Maramatanga Park Concept Plan

Decision Story

MARAMATANGA PARK

Reserve Concept Plan

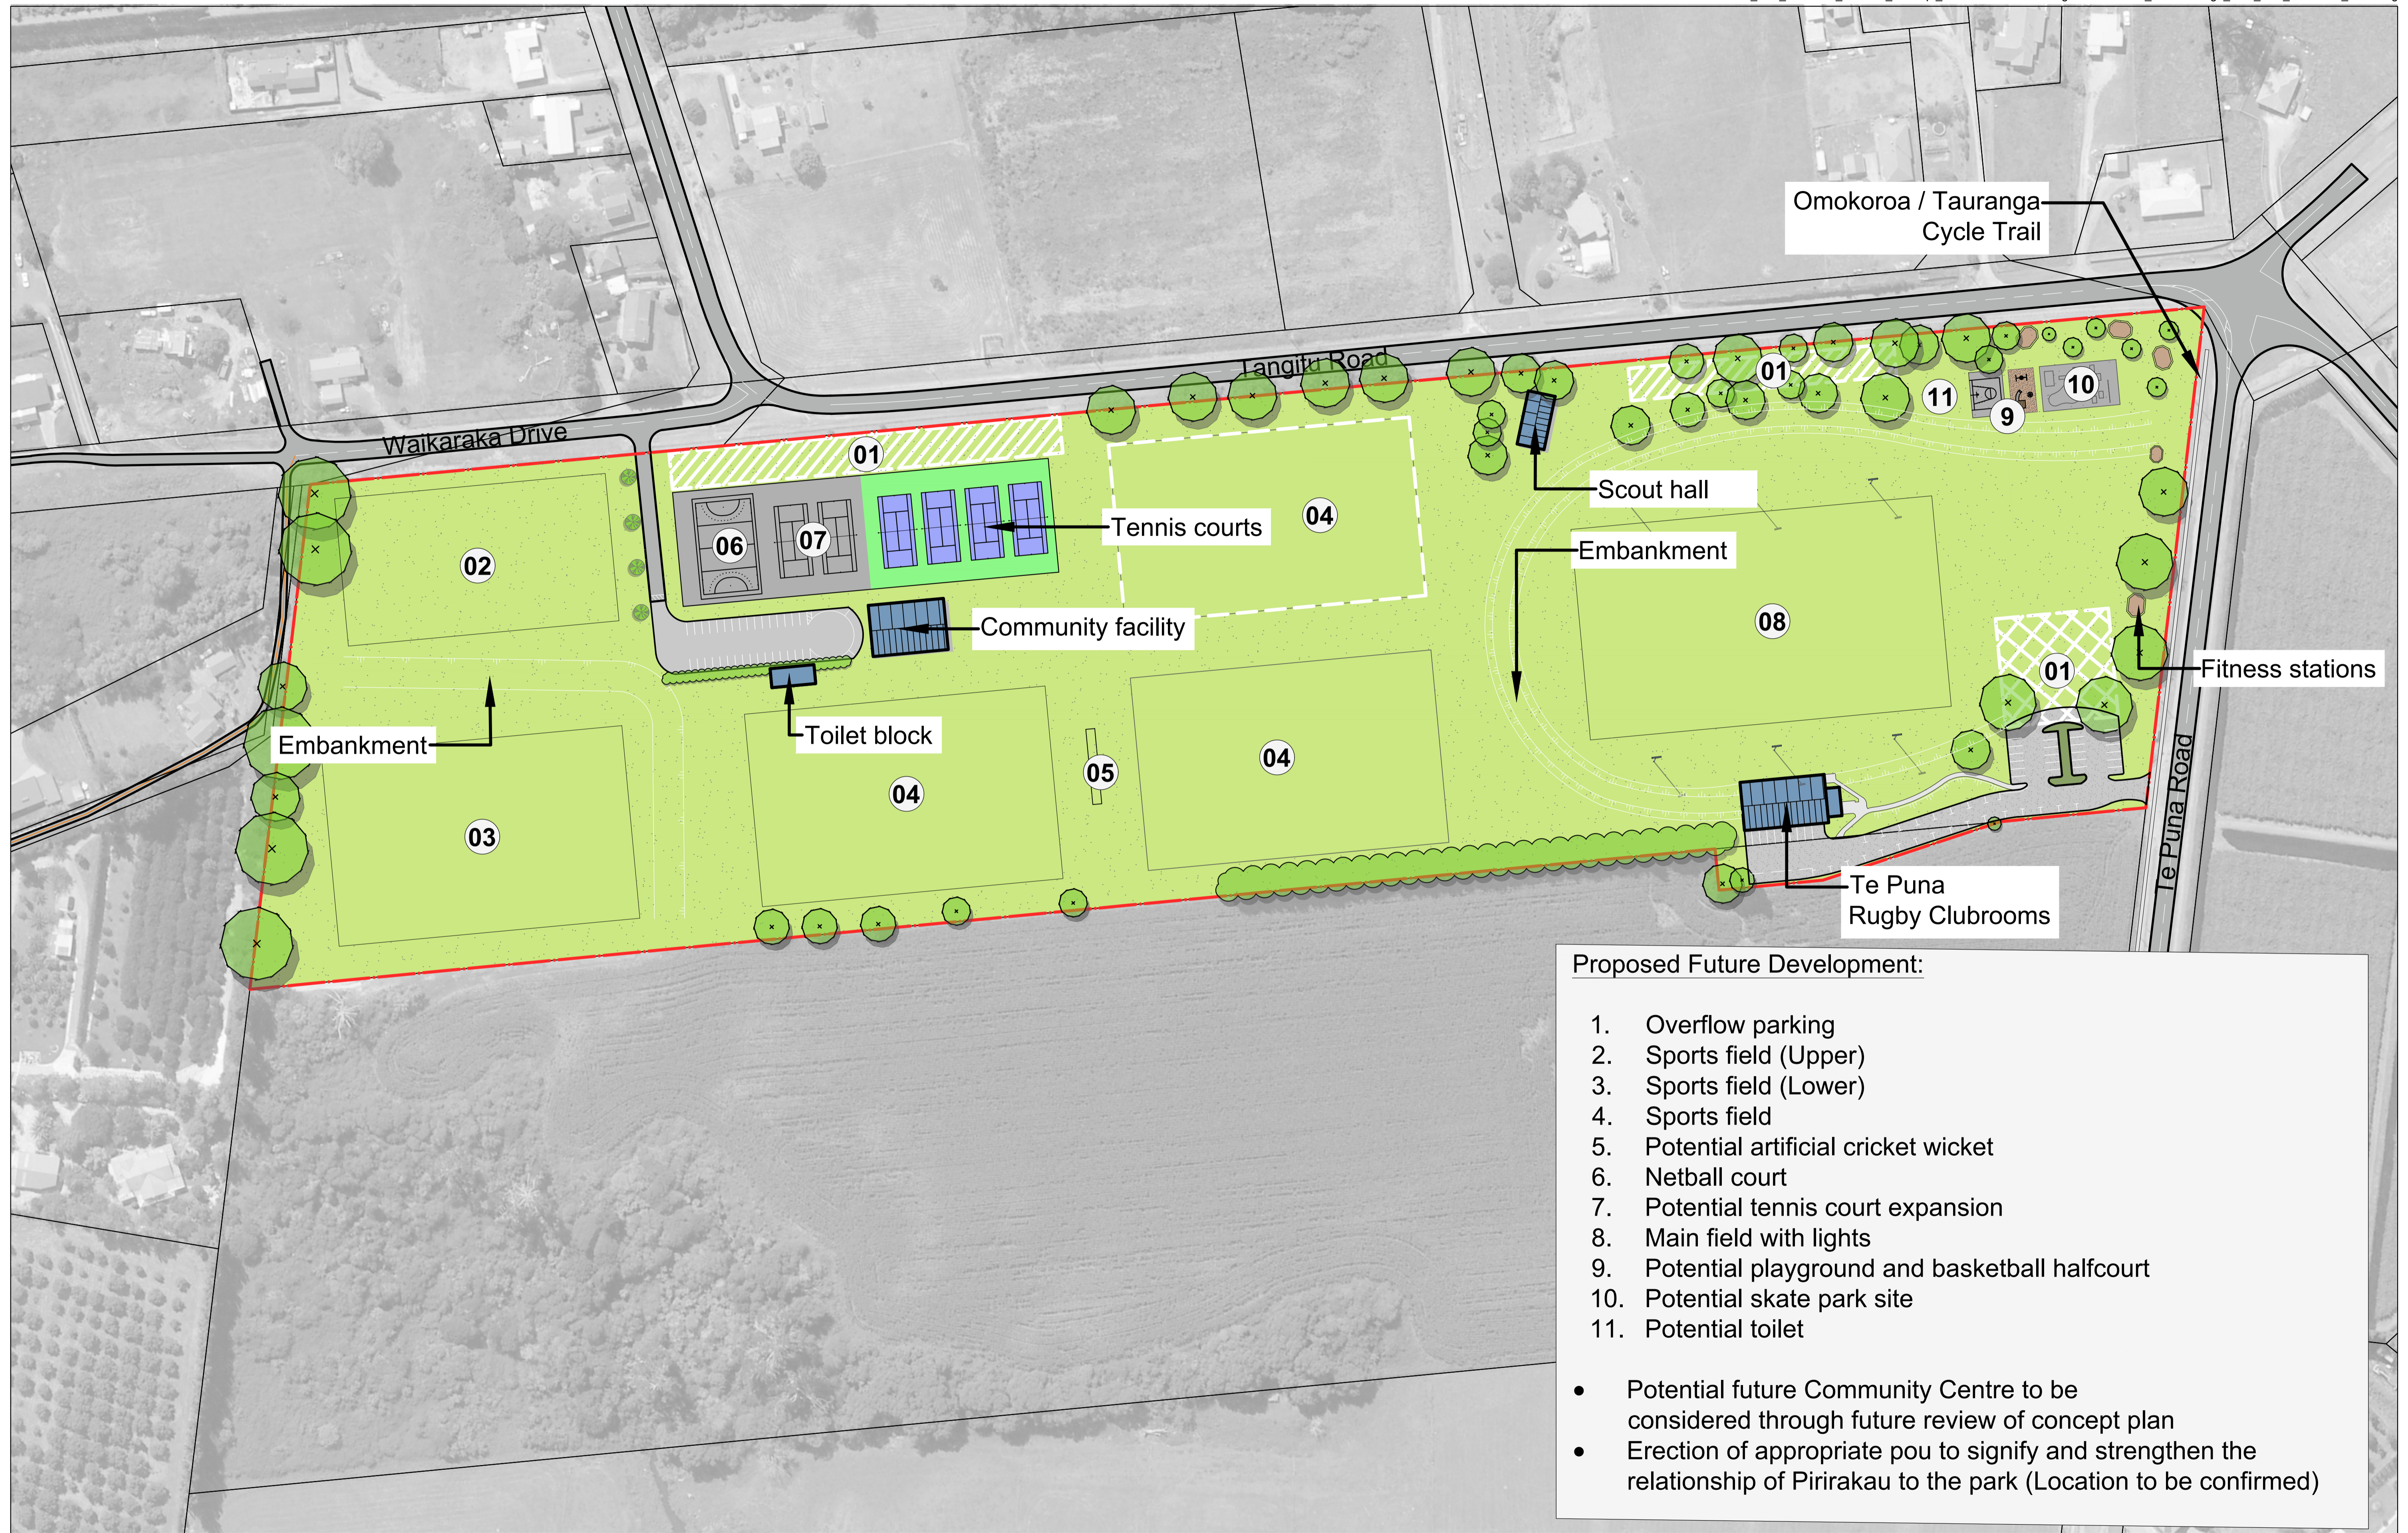
We are heartened by the comments made about the connection the Park has to Pirirakau hapū.

Considerable support was shown for new cycleway connection to the Park but there were concerns about the impact of the lack of car parks and the need for an additional toilet. We will be monitoring the impact of the cycleway including provision of car parks, toilet facilities, drinking water etc at Maramatanga Park. The proposed overflow locations shown in the Concept Plan can be amended as the impacts become clearer.

Members of the Tennis Club commented about the need to expand, but another submitter suggested extra courts were not needed. We continue to have a good working relationship with the Club and managing court space at Maramatanga Park has always been a priority for Council.

We received many comments supporting the proposed skate park and playground. Over recent years there has been a lot of support for these play areas district-wide. Occasionally opposition arises due to concerns about the sites becoming magnets for anti-social behaviour. Council's experience with these types of facilities at Katikati, Omokoroa, Te Puke, Maketu and Waihi Beach is that they have proven very successful through their popularity and through support from committed committees.

Several people were concerned about the lack of public toilet options. Due to vandalism resulting from the toilet block being located at the rear of the Community Centre, we have kept it locked. We will continue to work with users to make sure the toilet key is available for organised events.

Several Model Aircraft Club members supported the continued use of Maramatanga Park for flying. It is a permitted activity on reserves, which must meet the noise performance standards under the provisions of the District Plan. Council's Reserves and Facilities Bylaw also restricts how a person may operate power-driven model aircraft on a reserve. It is understood only electric model aircraft are used at the Park, which would need to meet the requirements above. Fuel or gas turbine powered planes are unlikely to be permitted because of the District Plan noise performance standards for the zone.

During community discussions, the idea of a future Community Centre for the wider Te Puna area was raised on the basis that it should be located on Council-owned land, i.e. Maramatanga Park. During this concept plan process, there was support for a future Community Centre at Maramatanga Park but rather than being site specific, the Plan would include a general statement: Potential future Community Centre building site to be determined later.

- Opportunity to erect appropriate pou to signify and strengthen the relationship of Pirirakau to the park.

The concept plan identifies potential sites to enable further discussion to assist the design and funding stage which will also include assessments of access, location of services and the proposed new toilet.

The plan identifies the location of a new toilet close to the proposed carpark, playground and skate park area to enable easy access. We anticipate the final location and timing of the toilet will coincide with completion of the design, assessments and funding stage of the proposed "play area" facilities.

Currently the Park is mown to the appropriate sports fields code standard, Type C – 20 to 40 mm grass height. Council would consider working with the Model Aircraft Club to arrange specific areas to be mown for the purposes of flying electric model aircraft. We would also use the opportunity to address any issues members may have regarding general use of the park and access to the toilet.
